SERVICE BULLETIN #140a December 9,1996

-Engineering Department-

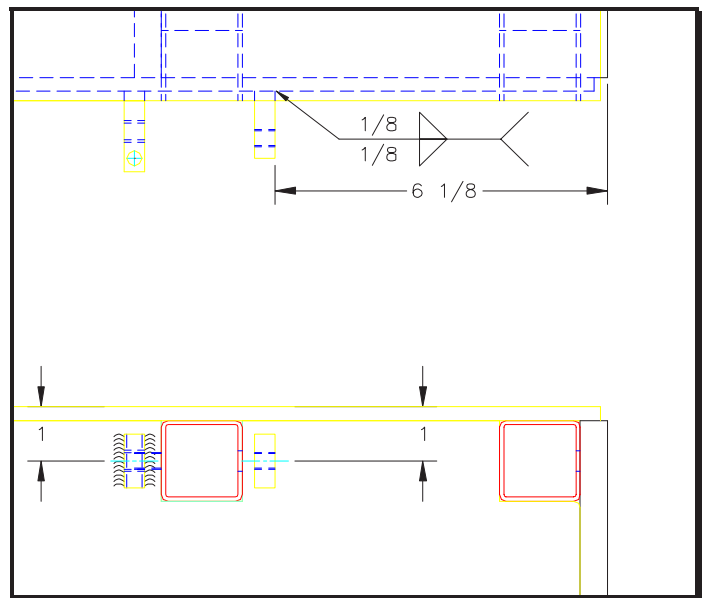
In order to keep the Lumber Stop rack an equal distance from the proximity switch we are sending a tab, setscrews and jam nuts to all **MiTek® Cyber Saw®** Owners.

Please weld the tab onto the Lumber Stop as per figure below and attached drawing.

- (1) Lumber Stop Mtg Tab
MiTek® P.N. B79814
- (1) SCREW-SET
SKTHDDOG 5/16-18x1"
MiTek® P.N. 334685
- (1) NUT-JAM 5/16-18
MiTek® P.N. 361653

Attached is a revised print of the Lumber Stop Weldment and Lumber Stop Assembly showing above update.
